Addendum # 2

Bid Opportunity: 25-7630-RFT - Laurentian Public School HVAC and Building Controls Upgrade

E701

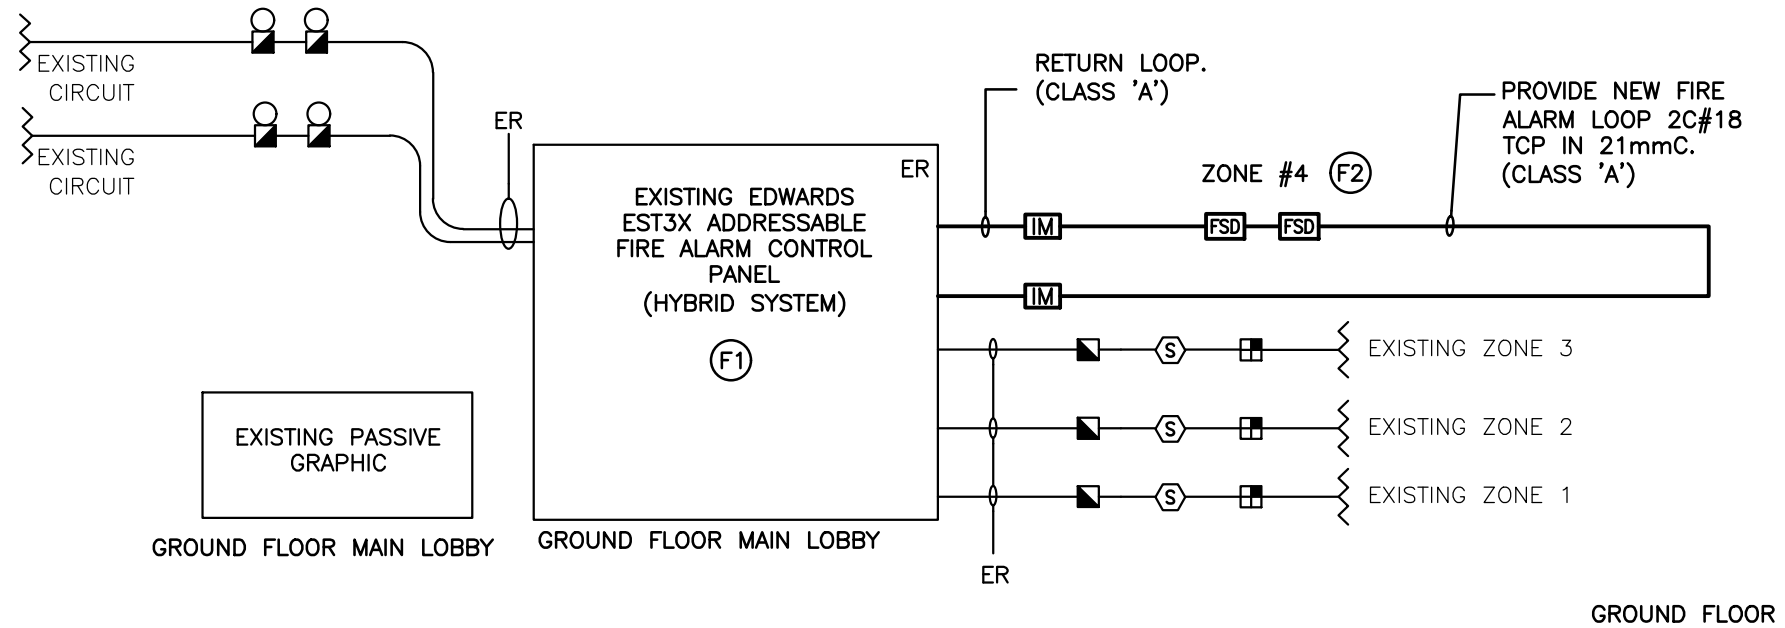
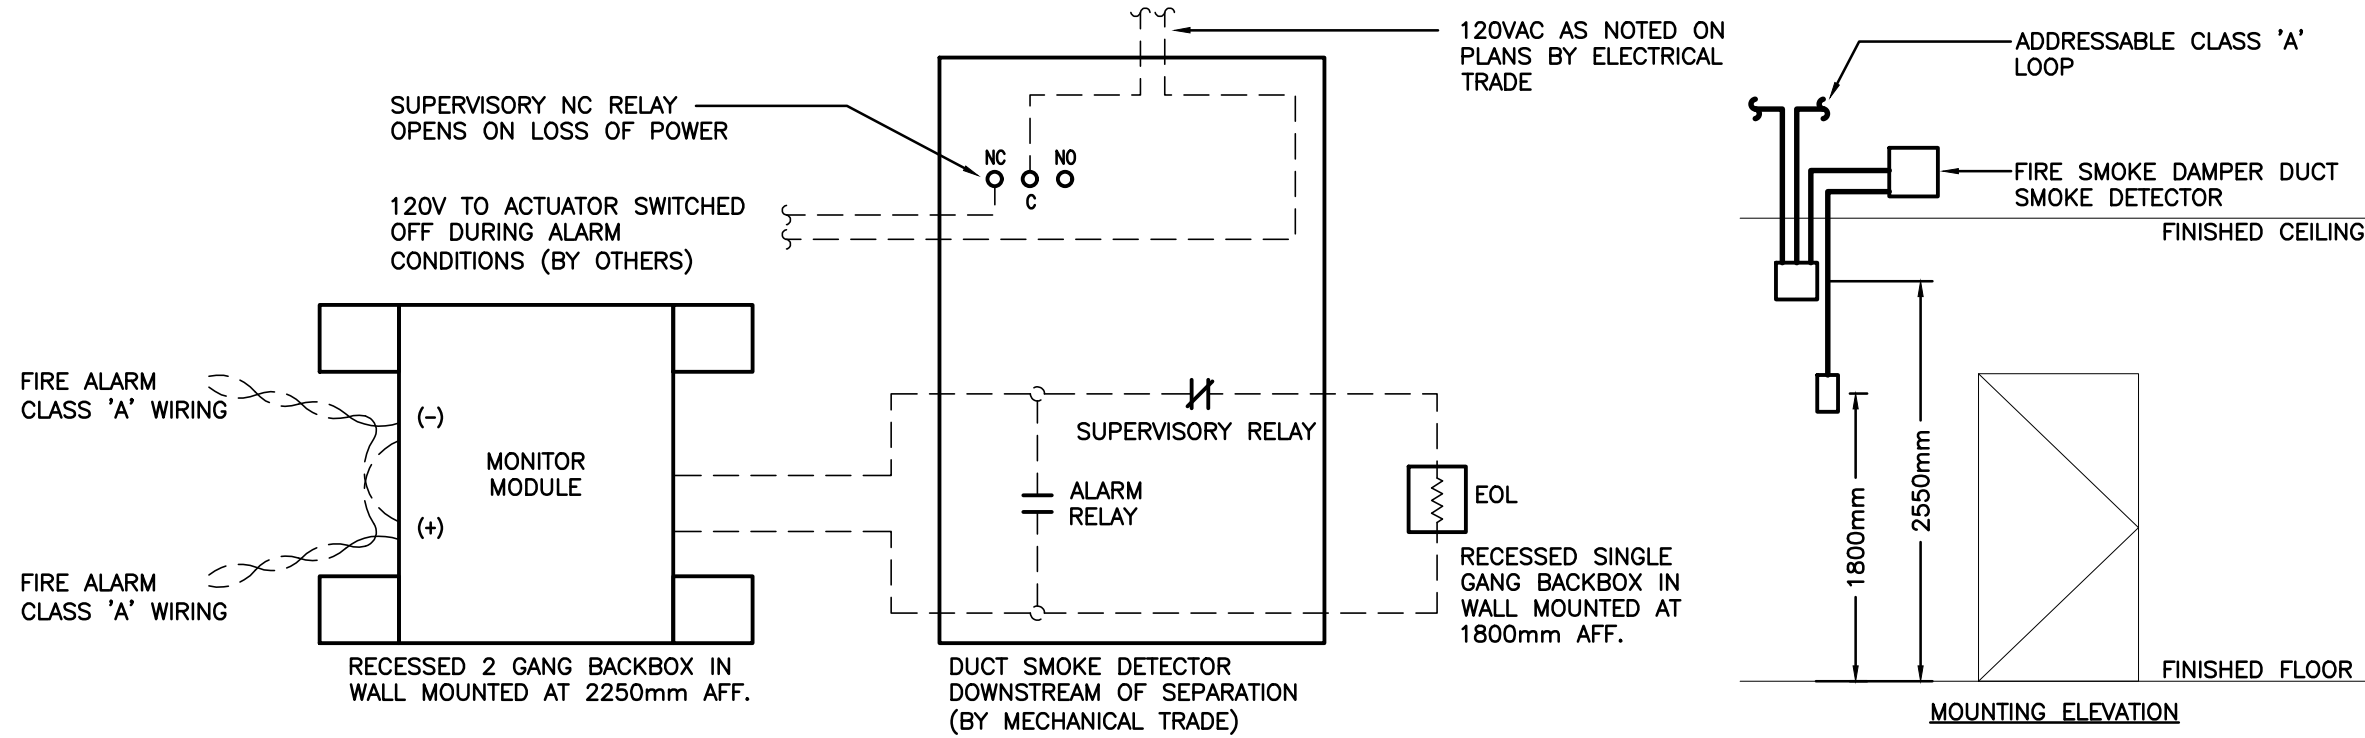
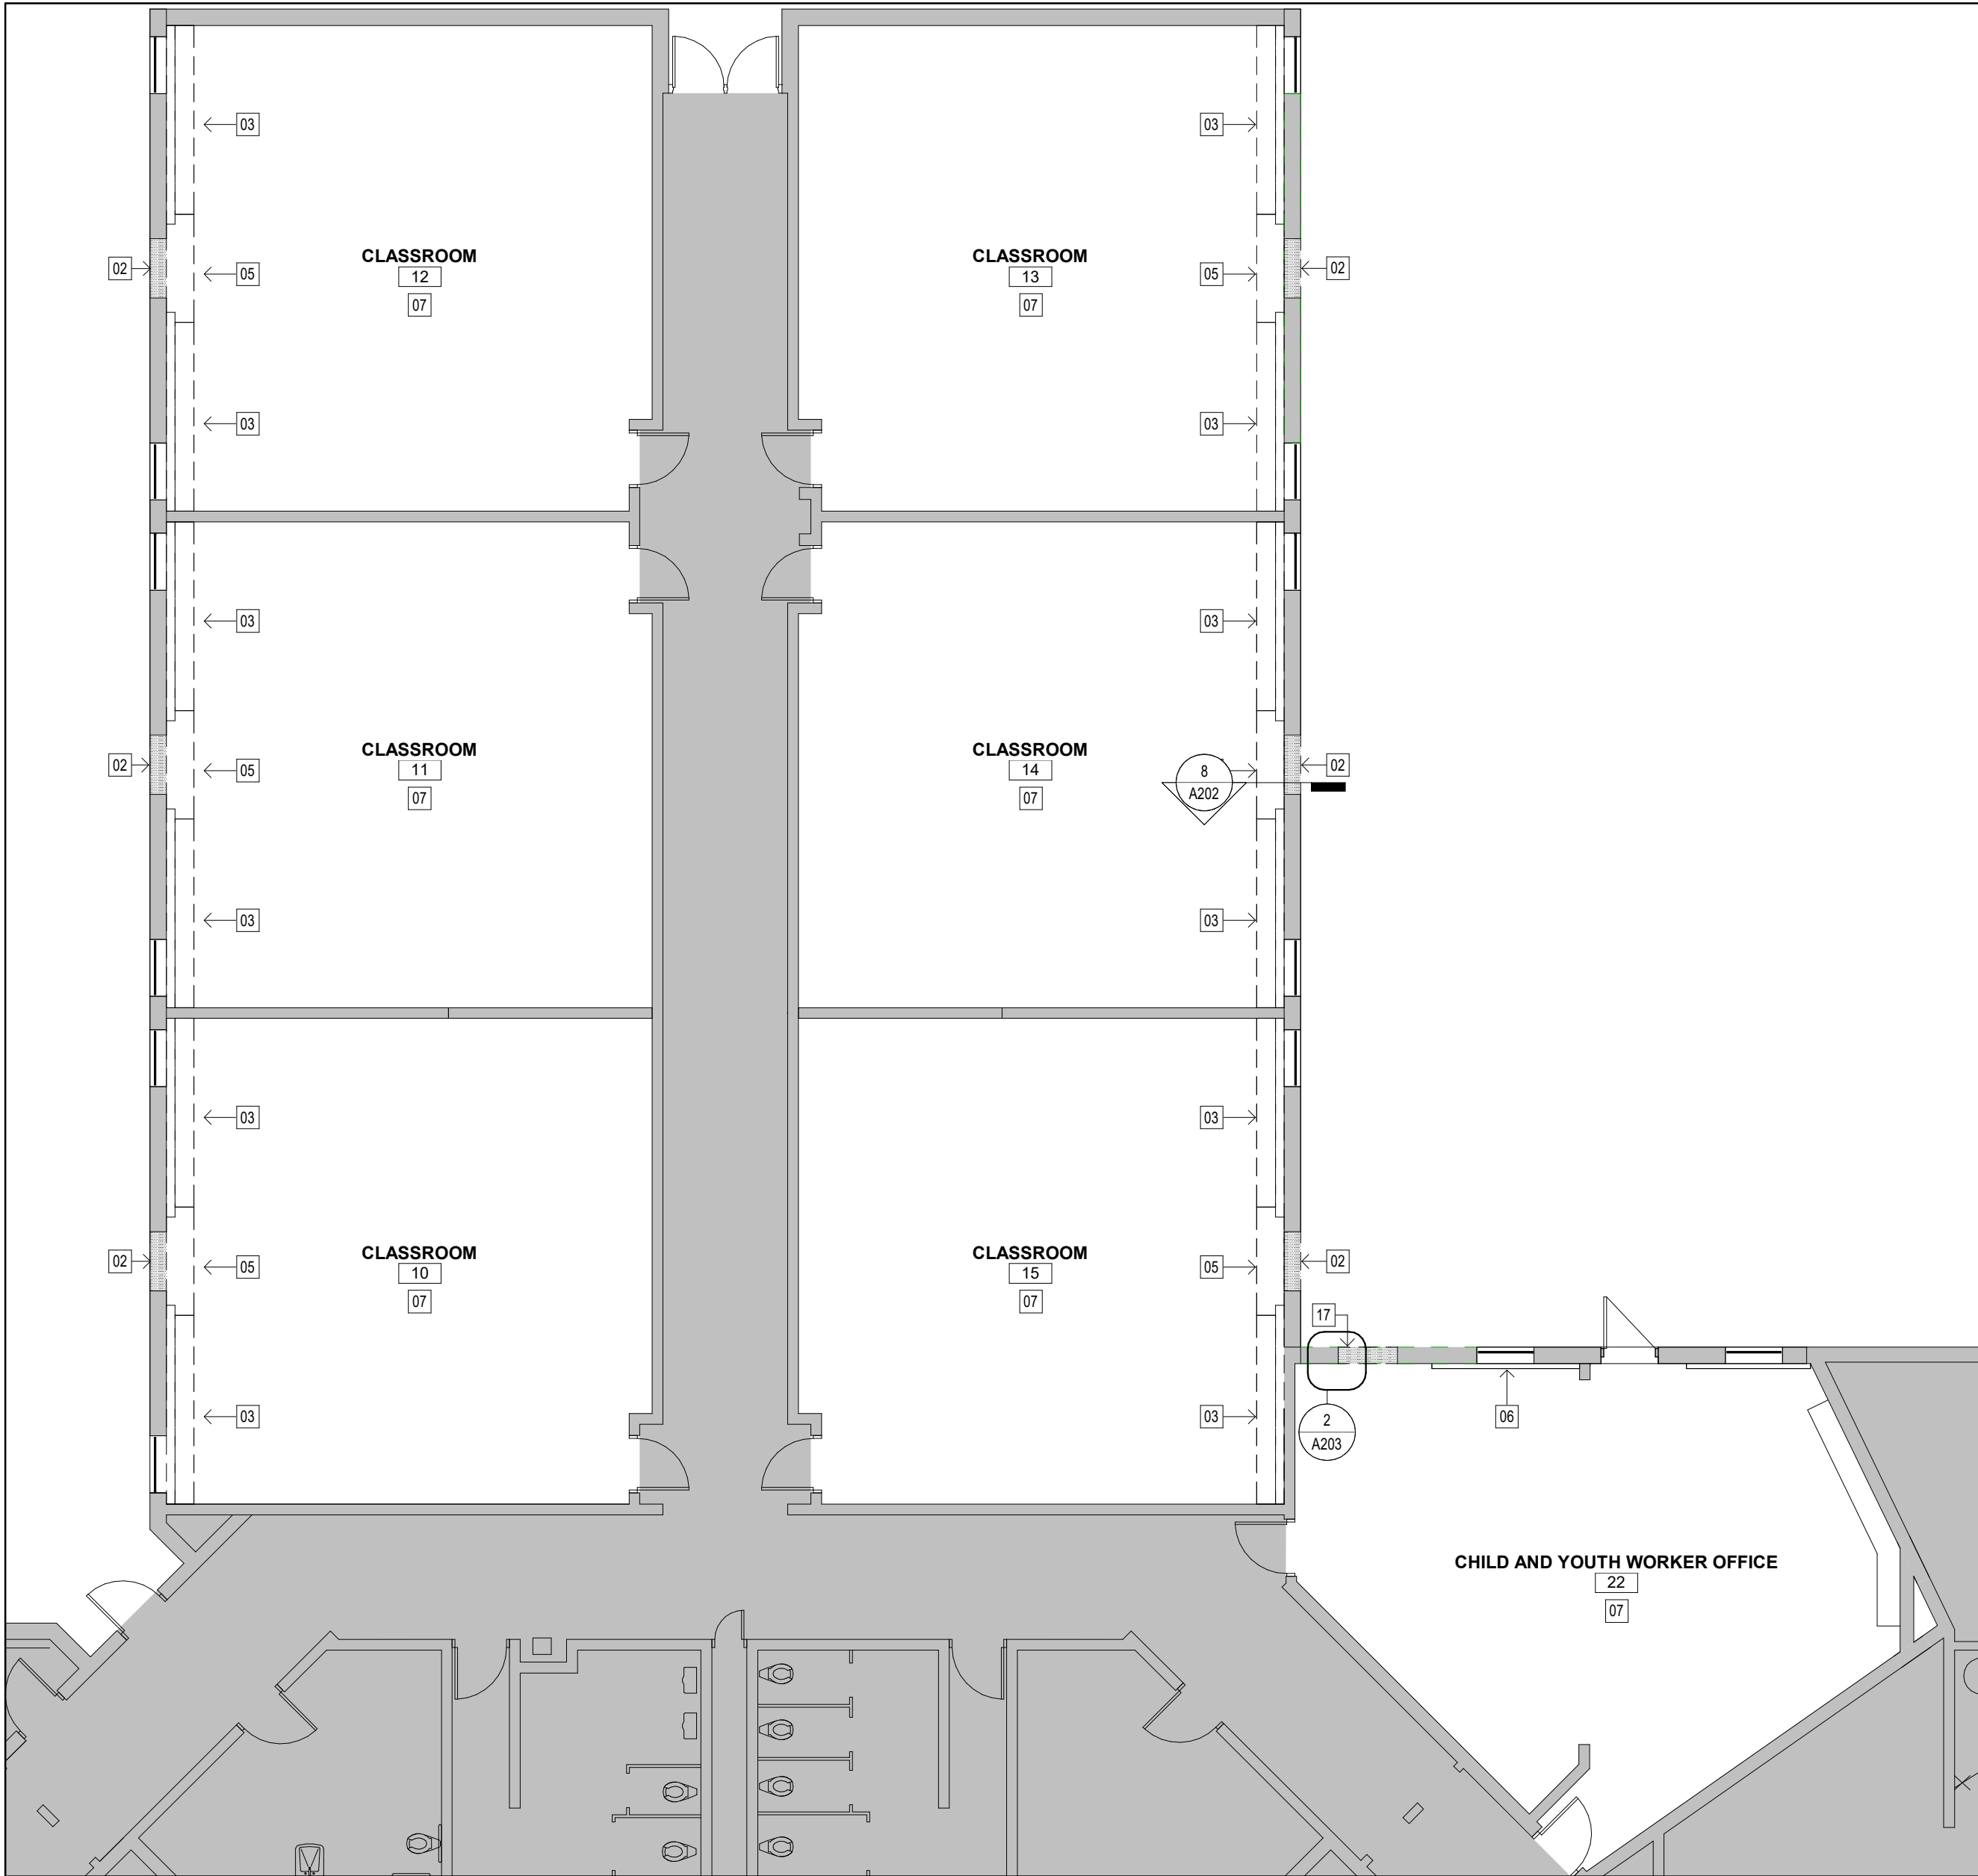
6.0 Reference Attached Reissued Drawing E701
